Maps of OMA, TDP and mean power

Piers Dawe
Mellanox Technologies

- Comments 140,141, 130, 129, 66, 70 and 18 relate to parameters average power, OMA, peak power and extinction ratio that are best discussed with the appropriate maps in view
- This presentation provides the maps and some discussion and recommendations

Map of OMA vs. TDP

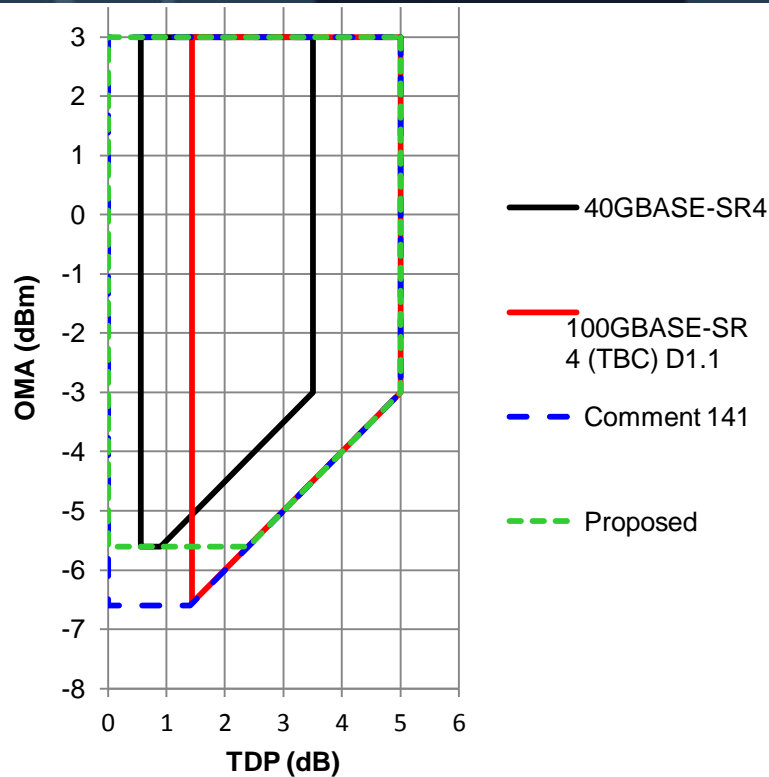
- Allowed Tx TDP and OMA in 40GBASE-SR4 and, for 100GBASE-SR4, in P802.3bm D1.1 (to be confirmed)
- Transmitter is not given credit for TDP < 0.9 dB

- A noiseless Tx with 1 ps risetime would have TDP of 0.44 dB for 40GBASE-SR4 and 0.76 dB for 100GBASE-SR4 (from spreadsheet model: ISI at decision timing offsets)
- For 12 ps, this becomes 0.56 dB or 1.44 dB (illustrated)
- TDP is not likely to be below 1.5 dB
- Cutoff line for TDP credit needs revision

- We should raise the minimum OMA for low-TDP Tx until there is a moderate flat region at the bottom
- Comment 141 proposed increasing the minimum OMA from -7.1 dBm to -6.6 dBm
- It turns out that isn't enough
- We might as well use the same limit as 40GBASE-SR4: -5.6 dBm
 - This makes operation and diagnostics of a mixed 40GBASE-SR4 / 100GBASE-SR4 network a little easier
 - No cost foreseen because this still offers an 8.4 dB tall setup window for any future low-TDP transmitter

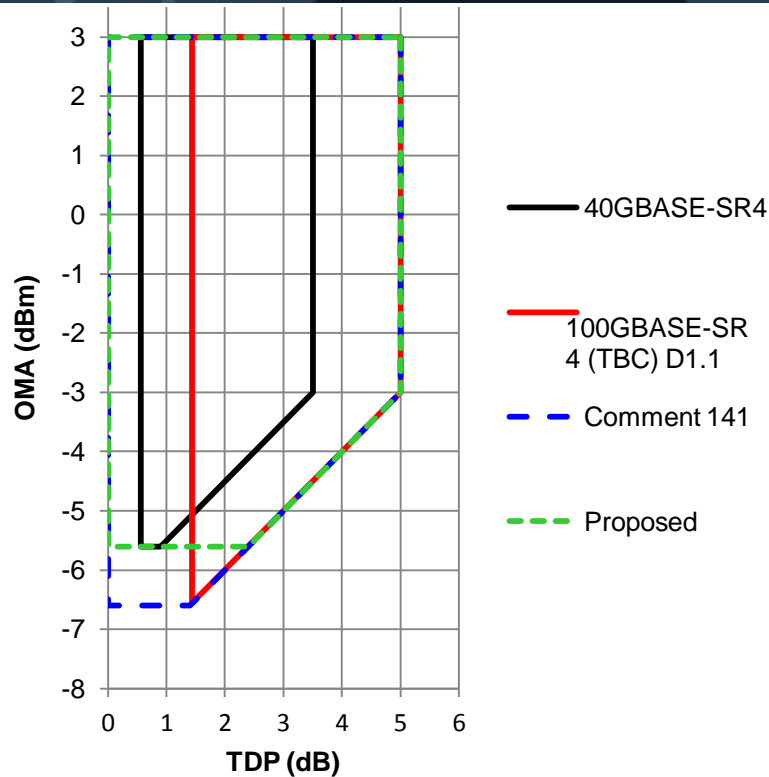
- Comment 18 proposes for Table 95–6, 100GBASE-SR4 transmit characteristics:
 - Insert note 'b' to spec line "Optical Modulation Amplitude (OMA), each lane (min)" : Even if the TDP < 0.9 dB, the OMA (min) must exceed this value.
- Instead of 0.9 dB, use 2.4 dB
- The minimum average power on each lane would also be increased
 - See next slide

Difference between lanes

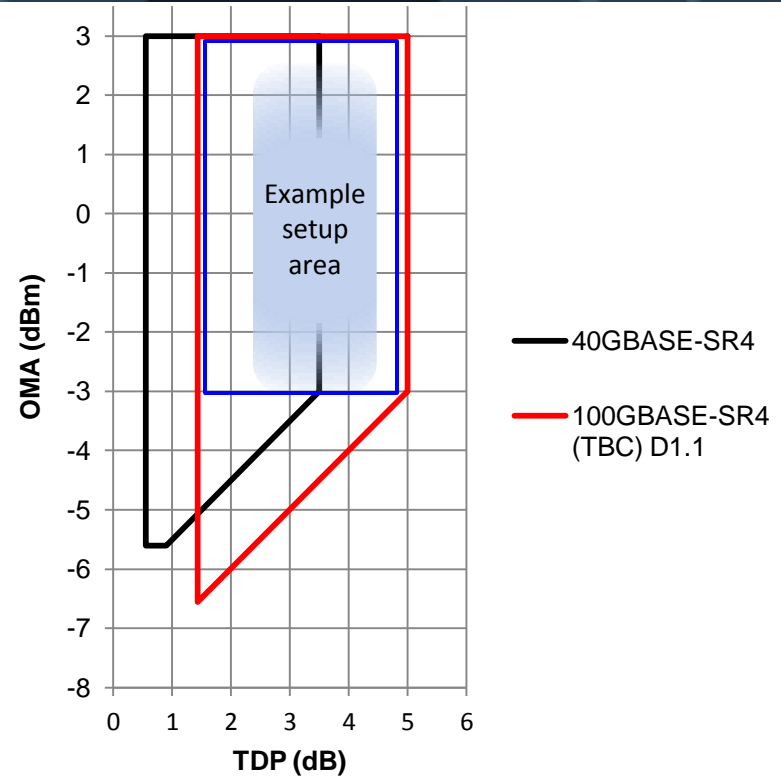
- Transmitters that make use of the maximum TDP spec can be set up by aiming within the blue rectangle
- Difference between max and min is 6 dB
 - Enough for setup
- This would also be the difference between any two lanes at the transmitter
- The difference at the receiver could be 1.9 dB more, because the loss of the lanes may not be equal
 - If the minimum attenuation is 0 dB/km
 - Total $3 - (-3) + 1.9 = 7.9$ dB not $3 - (-7.1) + 1.9 = 12$ dB (from slide 3)
- Use this to moderate the aggressor OMA in stressed receiver testing (comment 130)

Choosing minimum average input power at receiver

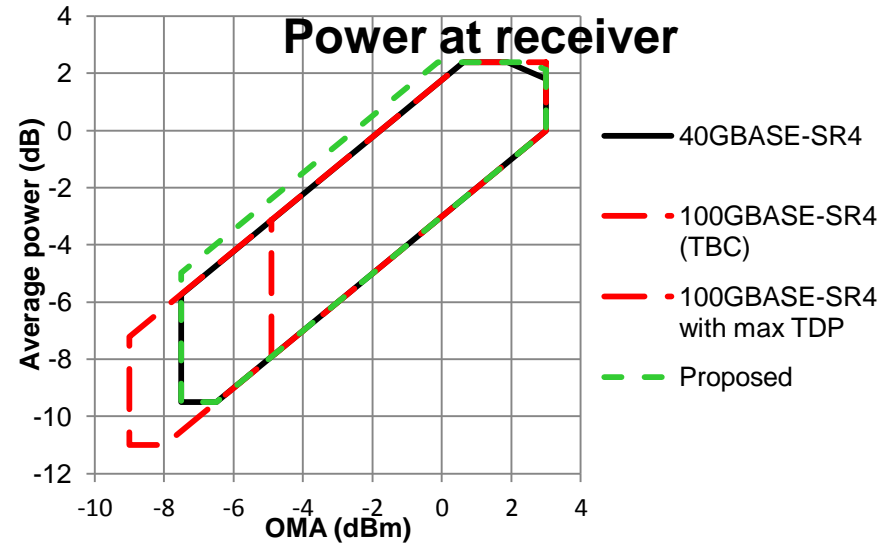
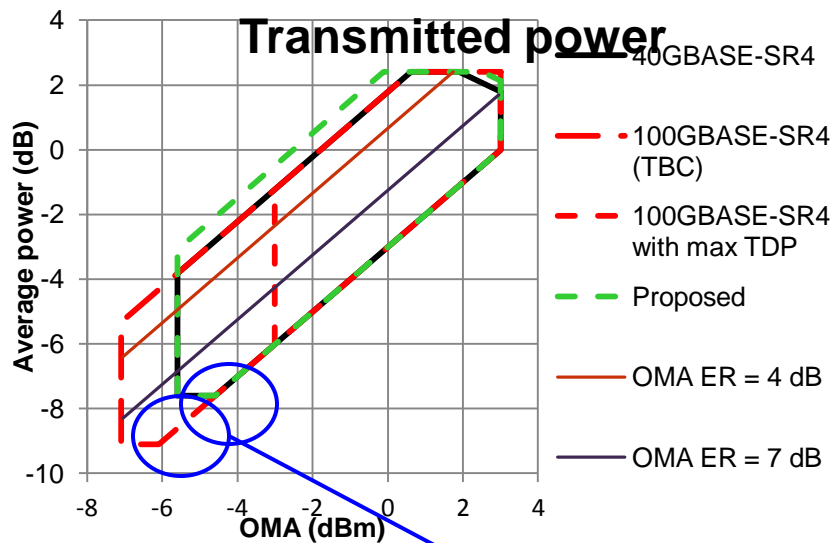
A directly modulated VCSEL is unlikely to have very high extinction ratio AND very low TDP

Power at receiver is 0 to 1.9 dB less than launch power

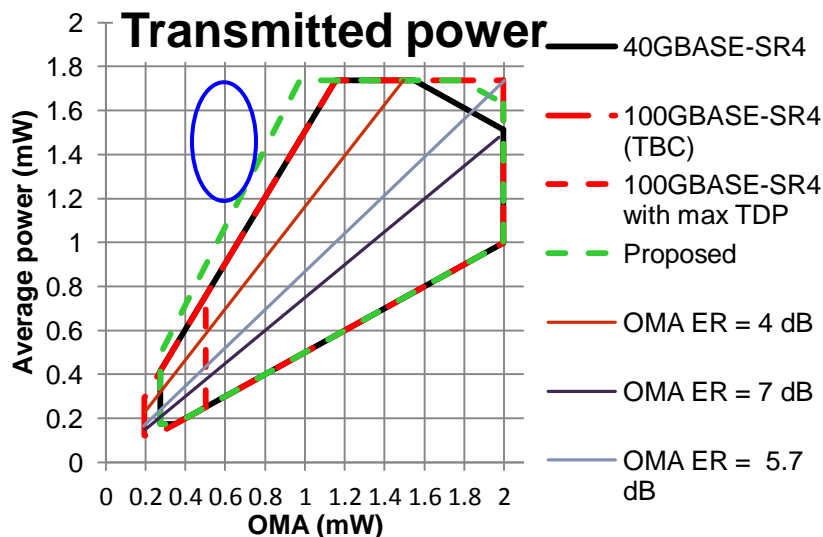
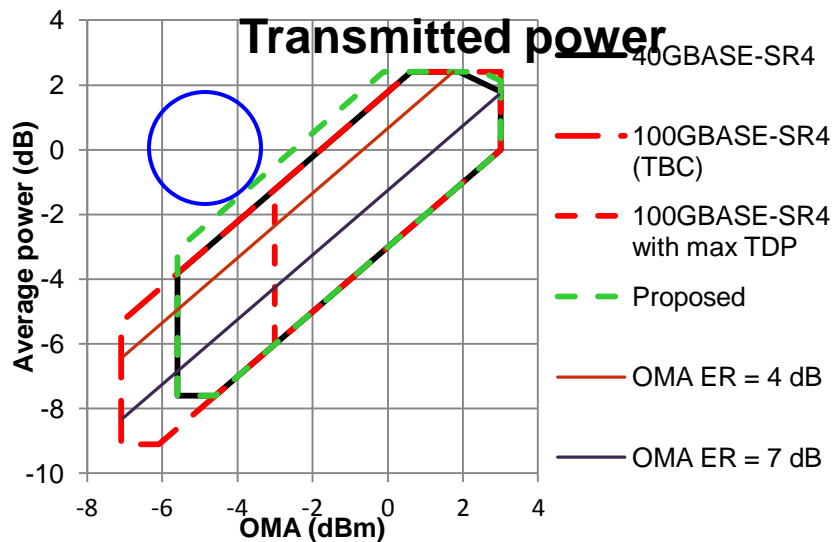
- Slide 4 shows that -5.6 dBm is a suitable Tx OMA minimum
- The draft -9.1 dBm minimum average launch power is unlikely to happen: it would need very high extinction ratio together with very low TDP
- -7.6 dBm, as in 40GBASE-SR4, looks suitable
- The minimum average input power at the receiver (TP3) would become -9.5 instead of -11 dBm
- Note: these maps assume that all ones and zeros are the same
 - No distinction between "OMA extinction ratio" and "SONET extinction ratio"
 - Peak power calculated as average power in ones – true peak can be higher because of overshoot

- For a relatively slow transmitter, "SONET extinction ratio" (as in 10G/40G/100G Ethernet as well as SONET and SDH) is lower than "OMA extinction ratio"
- Current draft spec is 3 dB minimum. Comment 66 and 70 criticise this
- Circled regions would have a very high ratio of average power to OMA (DC photocurrent to modulated photocurrent) which would put an unnecessary burden on the receiver's DC cancellation feedback loop (or equivalent)
- However, it may be advisable to relax the spec moderately, to 2.5 dB
- Note: in the plot on the right, straight lines are drawn between calculated vertices. If the intermediate points were calculated, the lines would be slightly curved

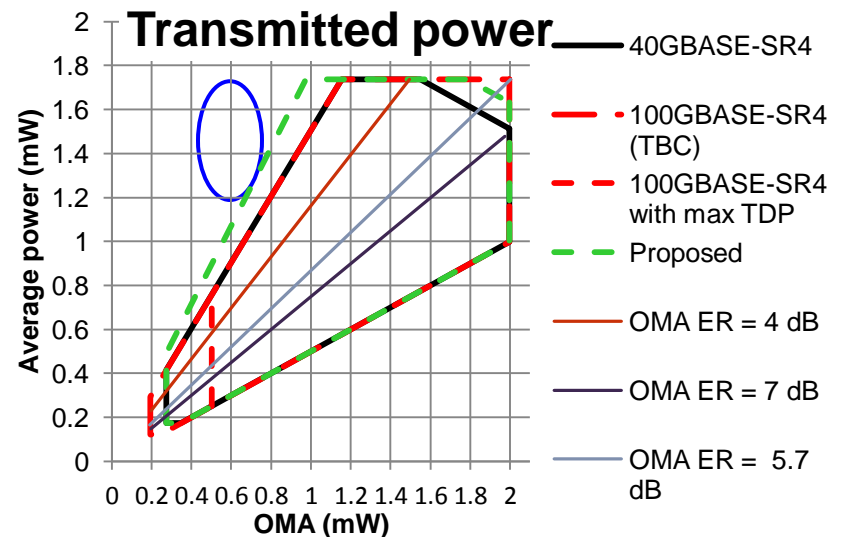
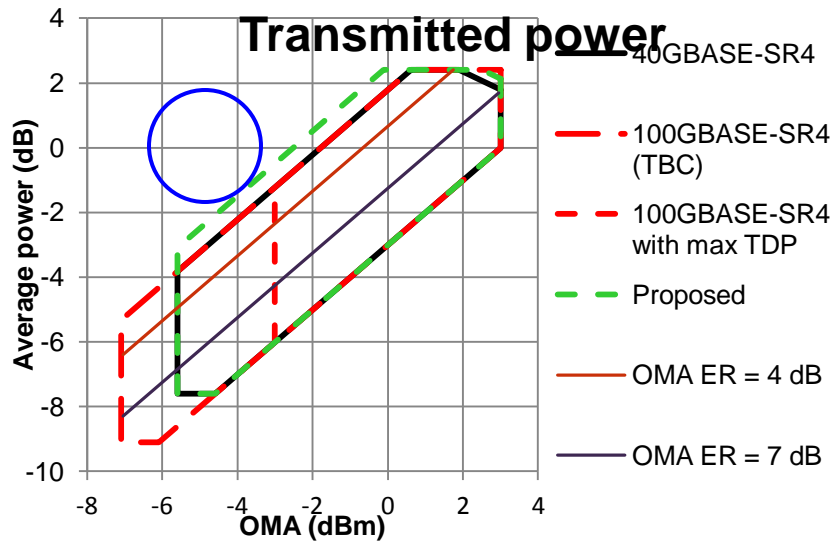
- 40GBASE-SR4 has a peak power limit of 4 dBm or 2.5 mW to protect the receiver from excessive photocurrent
- Without this, the peak power could be 4.37 dBm plus 0.8 dB or 20% higher because of overshoot, giving about 4.8 dBm or 3 mW
- A transmitter would have to have high overshoot AND a particular extinction ratio to create this peak power
- A maximum peak power spec protects the receiver at little to no inconvenience to the transmitter
- The limit should be a little higher than 40GBASE-SR4's 4 dBm
- Comment 129 proposes 4.2 dB, as illustrated

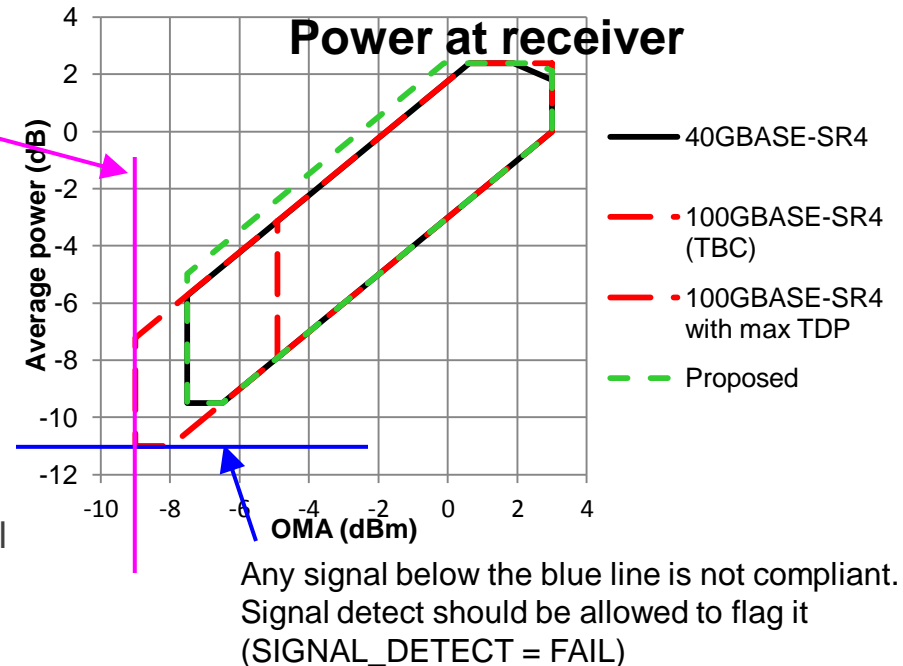
Any signal to the left of the magenta line is not compliant. Signal detect should be allowed to flag it (SIGNAL_DETECT = FAIL)

- Signal detect must detect a compliant signal: one that is to the right of the magenta line, above the blue line, and 100GBASE-SR compliant (pattern).
 - It doesn't have to check all these things
- Signal detect should be allowed to flag any non-compliant signal as non-compliant
 - It doesn't have to do so, unless the average optical power at the receiver (TP3) is -30 dBm or less
- Comment 140:
- Change
 - [(Optical power at TP3 \geq average receive power, each lane (min) in Table 95-7)
 - AND
 - (compliant 100GBASE-R signal input)]
- to
 - Compliant 100GBASE-R signal input at TP3 with OMA \geq -9 dBm and average optical
 - power \geq average receive power, each lane (min) in Table 95-7
 - (-9 would become -8.5 if another comment is accepted).
